Project	<b>IEEE 802.16 Broadband Wireless Access Working Group</b> < <a href="http://ieee802.org/16">http://ieee802.org/16</a> >	
Title	<b>Using Radio Signature in the CX_CC Channel and other Changes to Section 15.4.2.1.2</b>	
Date Submitted	<b>2006-11-09</b>	
Source(s)	John Sydor Communications Research Centre 3701 Carling Avenue Ottawa, Ontario	Voice: 613-998-2388 Fax: [Fax Number] <a href="mailto:john.sydor@crc.ca">john.sydor@crc.ca</a>
Re:	Changes to Draft Stanadard	
Abstract	Changes to Section 15.4.2.1.2 of Draft Standard (October 2006 Version)	
Purpose	Consolidate Radio Signature and CX_CC concepts; make editorial changes.	
Notice	This document has been prepared to assist IEEE 802.16. It is offered as a basis for discussion and is not binding on the contributing individual(s) or organization(s). The material in this document is subject to change in form and content after further study. The contributor(s) reserve(s) the right to add, amend or withdraw material contained herein.

## Using Radio Signature in the CX\_CC channel and other Changes to Section 15.4.2.1.2

Figure h42 - Distribution of CMI for BS and SS Radio Signature Applications

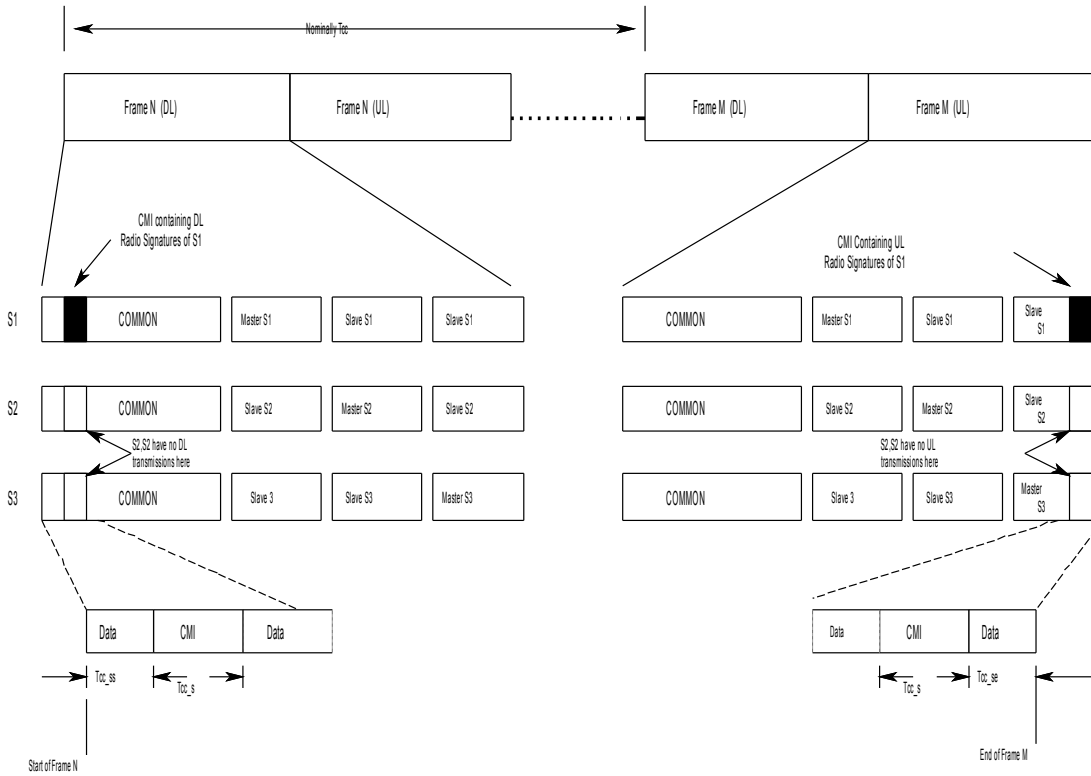
The discussion concerning the use of the Radio Signature operation and allocation of Radio Signature slots within the framing structure ( shown in Figure h42 current document), is not fully explained and when examined in detail, may not be sufficient to support its intended operation. Examples are given below.

Figure h 42 shows the ~~possible~~ allocation of the “radio signature” transmission opportunity using CMI and and the CX\_CC ~~for a given system,~~ using for example the Type 1 repetitive sub-framing pattern, ~~with a focus on system 2.~~ The scheme is equally applicable to Type 2 patterns as well.

***Delete Current Figure h42 and replace it with the following new figure.***
